Town of Duanesburg
Planning Board Agenda
November 16, 2023

**Re: Town of Duanesburg
Wishy Wash Site Plan & Special Use Permit Review
Amendment #3 for Engineering Services**

In response to the new comments (*in italics*), (previous comments unaltered font) of Doug Cole of Prime AE of April 12, 2023, we respond as follows (**in bold**):

SITE PLAN
CAR WASH ADDITION
ULTIMATE WASH WASH
 1000 WESTERN TURNPIKE
 WESTERN TURNPIKE

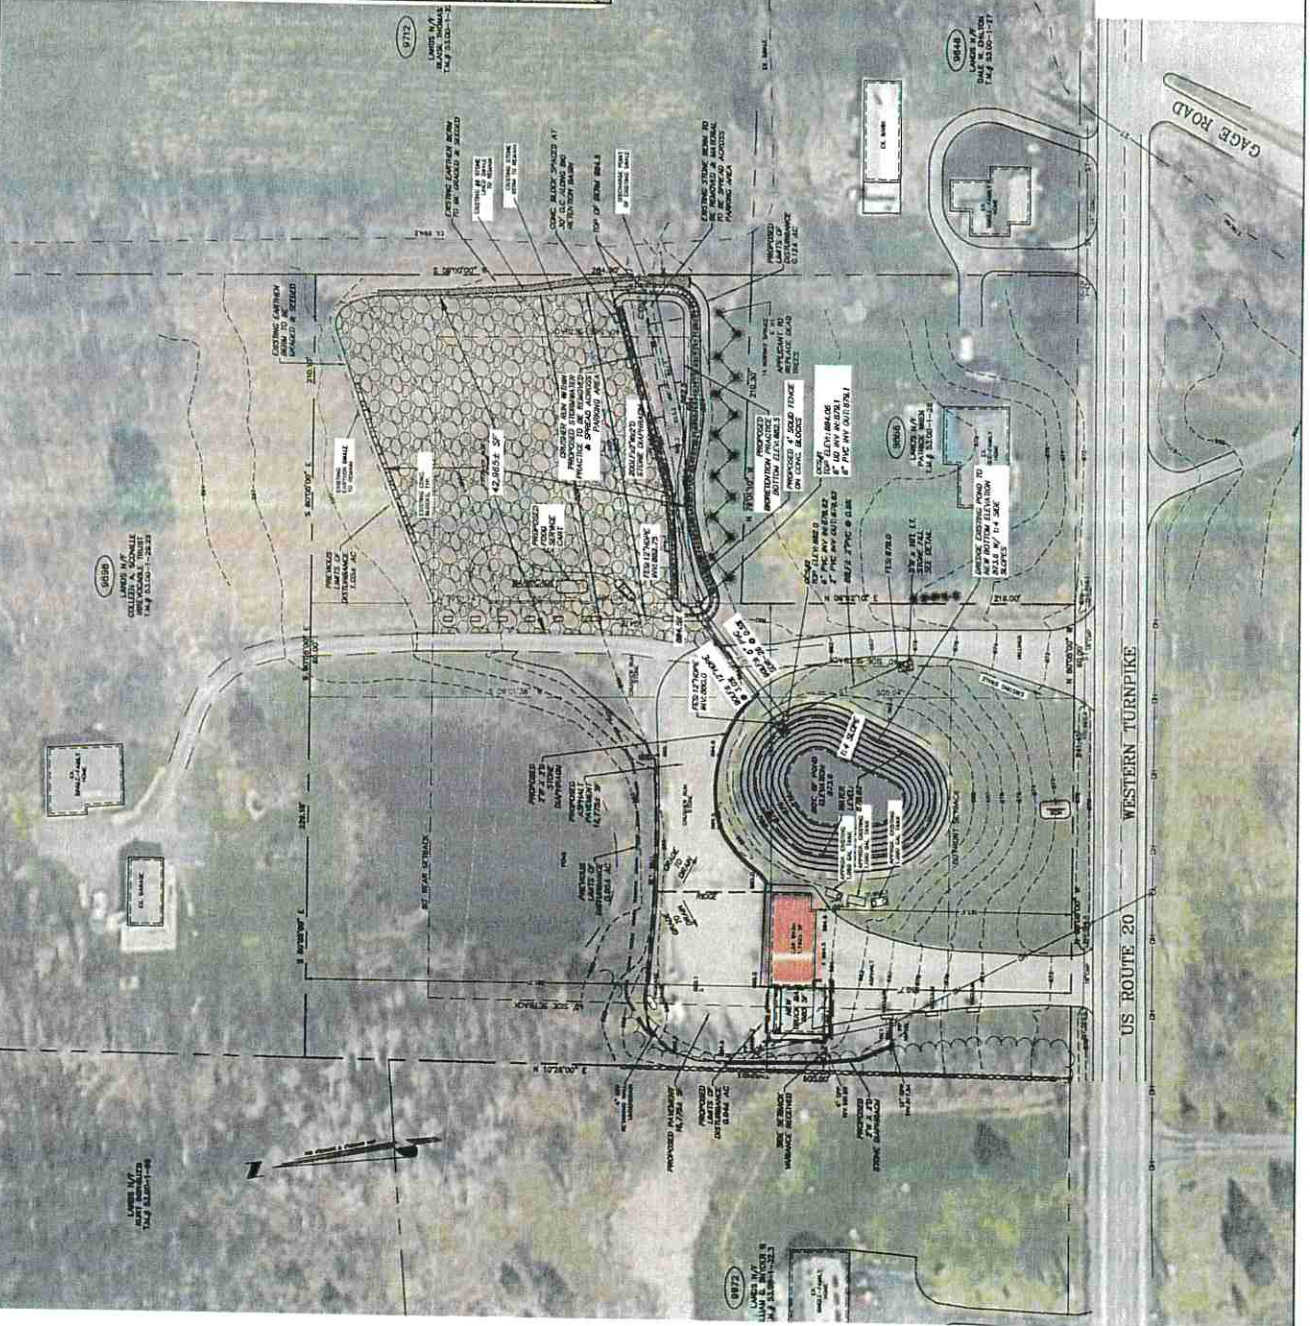
2. The proposed bioretention practice shows a 6" underdrain pipe to daylight discharging to the south of the facility onto lands of the applicant and a 12" HDPE outlet pipe and emergency spillway from the facility are shown exiting to the east onto lands of Thomas into an existing drainage swale which then flows through lands of Chilton prior to joining a stream that flows under NYS Route 20 near Gage Road. We have learned that a similar gravel parking area project was reviewed and approved by the Planning Board last year with a different stormwater design that kept all stormwater discharges on site, however, the design was not constructed as approved and the Town Permit was rescinded. In the December 15, 2021 letter to Dale Warner from Brett Steenburgh, P.E. regarding neighbor property flooding due to prior work performed on the gravel parking area, we located a statement attributed to Jamie Malcolm, NYSDEC Region 4 which said he "suggested that they maintain the existing drainage pattern and drain the pad to the southeast corner and not try to create the swale towards the car wash driveway and down US Route 20 ... as it may cause problems within the highway drainage system and inundate the existing culverts under the driveways of Wren and Chilton." We have not verified this statement with Mr. Malcolm, however, it is in keeping with NYSDEC requirements that the project design must ensure that there is no increase in runoff from a new development project and that there are no adverse effects downstream of the project. We understand that a bioretention practice has been designed to mitigate the offsite impacts of this project, however, since there are own issues with the current drainage pattern, we ask that the applicant provide additional information why the original plan to keep discharges on site are not practical if proper stormwater management practices are put into place to mitigate effects on the Route 20 drainage system and neighboring driveway culverts. Please also refer to our further comments on the stormwater design in the Drainage Narrative section of this letter. We have read the response to this comment in the 10/7/22 response letter from ABD, which did not answer the question above. Additionally, there are still concerns as noted below:

2b. Review of the Stormwater Design Manual (SWDM) shows that Bioretention is an acceptable practice for water quality treatment but is not to be used for water quantity control. An appropriate quantity control practice needs to be included for this project. Please refer to comment 5.e under SWPPP section.

2c. The anticipated water quantity control practice could be situated at the southwest corner of the gravel parking area. The stormwater design point would be changed to the culvert under Route 20 and the applicant/owner would have full control over the stormwater management system up to the point it empties into the ditch at Western Turnpike. The applicant responded that the "quantity control will be handled via a dry detention basin", however, we see no such structure on the site plan.

4. The Site Plan shows that the proposed additional bay is encroaching more than 20 feet into the 40-foot side lot setback, however, the Applicant has indicated they have a setback variance. Please provide a copy of the approved variance. We acknowledge that the Applicant has made the request for a copy of the approved variance from the Town, however, we have not been provided this document for review to date.

8. The plans appear to be missing the required grass filter strip between the stone diaphragm and Bioretention practice for pretreatment of direct runoff from the parking lot. The Stormwater Design Manual section referenced for Design Guidance of filtering systems in the applicants response states that "Adequate pretreatment for bioretention systems should incorporate all of the following: (2) grass filter strip below a level spreader or grass channel. (b) gravel diaphragm and (c) a mulch layer." ('Adequate' and 'all' are underlined for emphasis). The grass filter strip will catch fines and keep the stone diaphragm from clogging and becoming ineffective.

9. *The Drainage Narrative in Appendix E of the SWPPP, page 3, states that "Two new trenches are proposed along the edge of pavement that will collect stormwater from the asphalt surface. There is a negligible difference in runoff volume generated from the existing impervious crusher run stone and proposed impervious asphalt." The plans show a 12" pipe outlet from the stone trench without any treatment practices associated with this concentrated flow. The plans and SWPPP should be revised to include the proper stormwater treatment for a redevelopment project in this area of the site. We disagree with the applicant that this is not a case of redevelopment. As stated in the SDM in Chapter 9, redevelopment includes reconstruction of existing impervious surfaces. Please review section 9.2.1 of the SDM and accordingly size or describe the WQv practices to meet the requirements.*

10. *Please label the proposed stone swale along the eastern edge of the parking lot on the site plan.*

See revised stormwater plan. We are proposing to partially fill in the existing pond with clay excavated from the bio retention area. By doing so, more than adequate storage will be provided for the 100-yr storm event. An outlet control structure is proposed with a 2-inch PVC discharge to slowly release the 100-year storm at slow flow rate of 0.16 cfs.

See response to comment 2b above.

Not required. "Should" is defined in the manual as meaning a recommendation. Also, the detail from the manual you provided in your letter shows the stone diaphragm upstream from the grass filter strip, therefore, having no benefit on the stone diaphragm.

This is not a case of redevelopment; it is just a building addition. However, a 2'w by 2'deep stone diaphragm trench is proposed at the westerly end of the Wishy Wash exist drive and along the edge of gravel nearest the pond to handle stormwater runoff, as depicted on the enclosed plans.

The existing stone swale is labeled on the enclosed plans. There is no proposed stone swale on the plans.

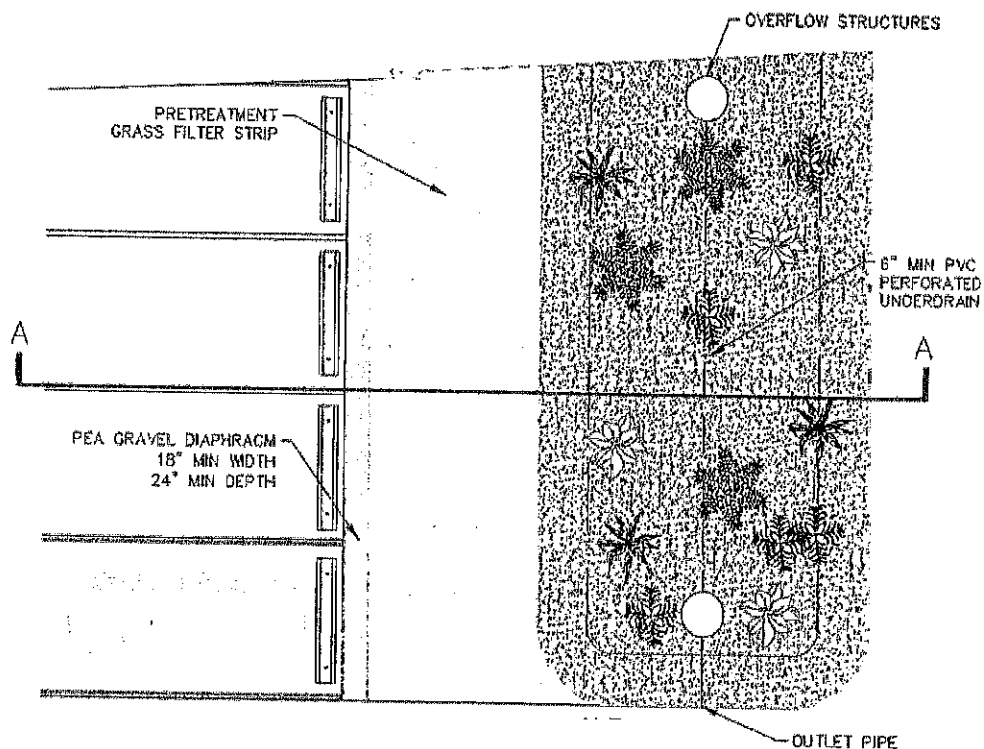
2. The proposed bioretention practice shows a 6" underdrain pipe to daylight discharging to the south of the facility onto lands of the applicant and a 12" HDPE outlet pipe and emergency spillway from the facility are shown exiting to the east onto lands of Thomas into an existing drainage swale which then flows through lands of Chilton prior to joining a stream that flows under NYS Route 20 near Gage Road. We have learned that a similar gravel parking area project was reviewed and approved by the Planning Board last year with a different stormwater design that kept all stormwater discharges on site, however, the design was not constructed as approved and the Town Permit was rescinded. In the December 15, 2021 letter to Dale Warner from Brett Steenburgh, P.E. regarding neighbor property flooding due to prior work performed on the gravel parking area, we located a statement attributed to Jamie Malcolm, NYSDEC Region 4 which said he "suggested that they maintain the existing drainage pattern and drain the pad to the southeast corner and not try to create the swale towards the car wash driveway and down US Route 20 ... as it may cause problems within the highway drainage system and inundate the existing culverts under the driveways of Wren and Chilton." We have not verified this statement with Mr. Malcolm, however, it is in keeping with NYSDEC requirements that the project design must ensure that there is no increase in runoff from a new development project and that there are no adverse effects downstream of the project. We understand that a bioretention practice has

been designed to mitigate the offsite impacts of this project, however, since there are known issues with the current drainage pattern, we ask that the applicant provide additional information why the original plan to keep discharges on site are not practical if proper stormwater management practices are put into place to mitigate effects on the Route 20 drainage system and neighboring driveway culverts. Please also refer to our further comments on the stormwater design in the Drainage Narrative section of this letter. *We have read the response to this comment in the 10/7/22 response letter from ABD, which did not answer the question above. Additionally, there are still concerns as noted below:*

- a. There needs to be test pit data that shows the proposed bottom of the Bioretention practice will be at least 2 feet above the high groundwater table. There is a note on the detail for the practice about using a poly-liner if the separation cannot be met, but this should be known at this point in the process. *The applicant has stated that groundwater is expected 18" below the surface and that is why a poly-liner has been selected. We accept this response.*

- b. Review of the Stormwater Design Manual (SWDM) shows that Bioretention is an acceptable practice for water quality treatment but is not to be used for water quantity control. An appropriate quantity control practice needs to be included for this project. *Please refer to comment 5.e under SWPPP section.*

Figure K.5 On-Line Versus Off-Line Schematic

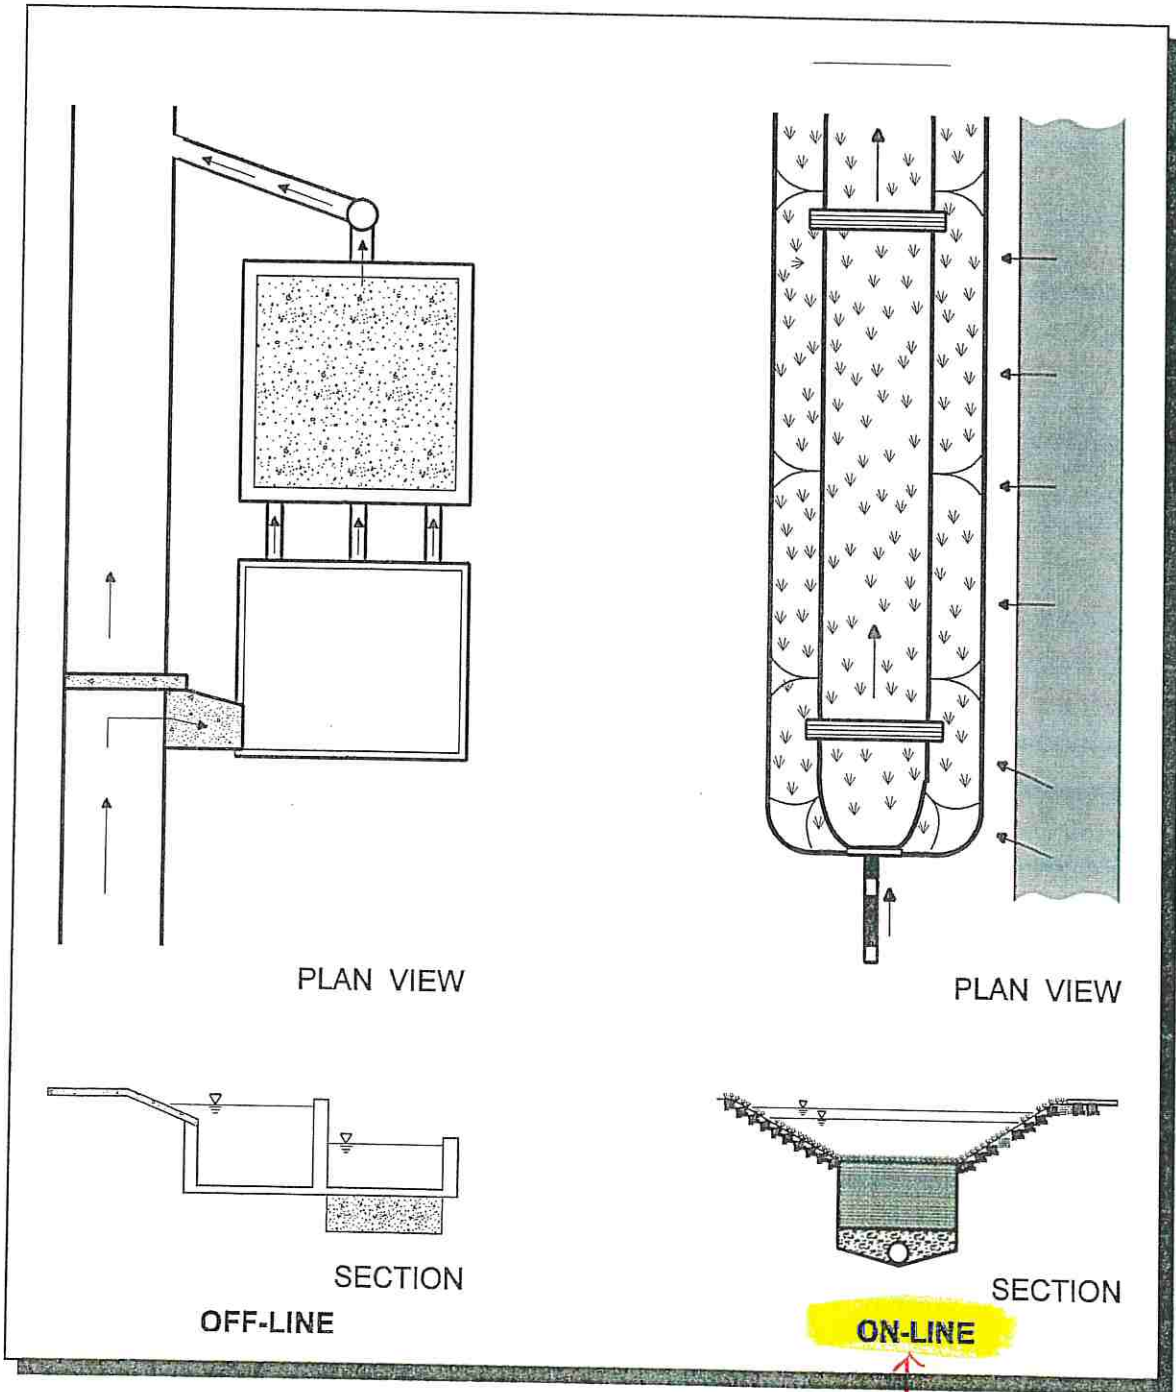
System being proposed
